# TENNESSEE DEPARTMENT OF ENVIRONMENT AND CONSERVATION DIVISION OF SOLID WASTE MANAGEMENT SOLID WASTE DISPOSAL FACILITY EVALUATION

NAME OF SITE TVA KINGSTON FOSSIL Plant	ndf.11	REGISTRA	TION NUMBER 73 - 0094		DATE /03
LOCATION (physical) Rd KingsTin, Tr		1	PURPOSE ( ) Complete ( ) Complaint	( ) Foll ( ) Oth	ow-up
OWNER/OPERATOR /			TYPE OF FACILITY ()		CLASS II
TI/A / Lind a Cambel				CLASS III	() CLASS IV
V1	V2				V1 V2
Inadequate vector control 8010		Leachat	te improperly managed	8330	
Access not limited to operating hours 8020		Inadequ	late leachate collection		,
Inadequate artificial or natural barrier 8030		syste		8340	
Inadequate information signs 8040		1 1	te observed at the site	8350	
Unsatisfactory access road(s)/parking	,	T .	te entering runoff	8360	
area(s) 8050	_ —		te entering a water	0070	
Certified personnel not present		cou		8370	<del></del>
during operating hours 8060			ate gas migration control	8380	
Unapproved salvaging of waste 8070		syste		0300	<del></del> ,
Evidence of open burning 8080 Inadequate fire protection 8090			ate maintenance of gas ation control system	8390

RDAs 2202 and 2499

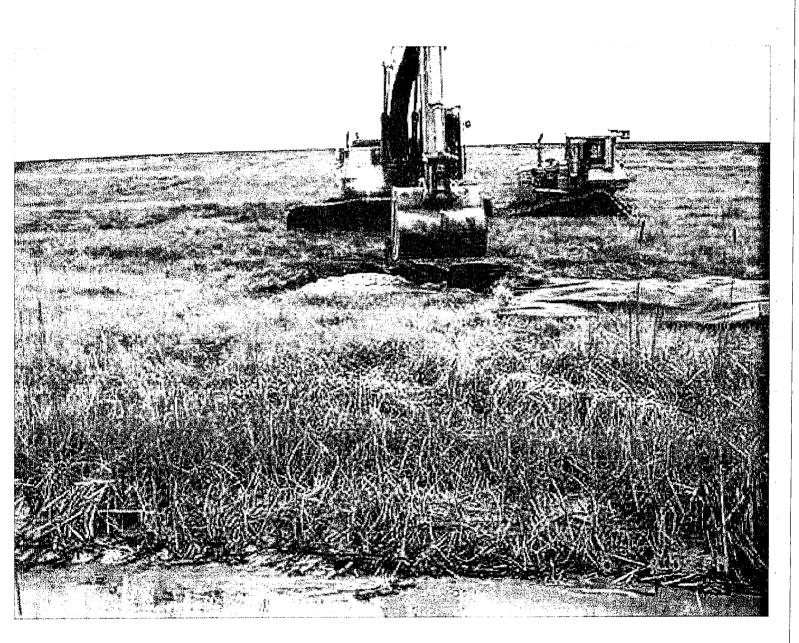
- 4. Photos of barriers to keep ash from going to the river.
- 5. Photos of repairs as they progress.
- 6. Explain the short term fix.

TVA has drained the dredge cells and stopped dredging to reduce the hydraulic loading on the lower dikes. In addition, TVA has placed combinations of filter fabric, rip rap and crushed stone on the affected area.

As an interim operation, TVA is directly removing ash from the pond and stacking the material on the eastern side of dredge cell 2. Development of a temporary dredge cell within the active ash pond is under consideration.
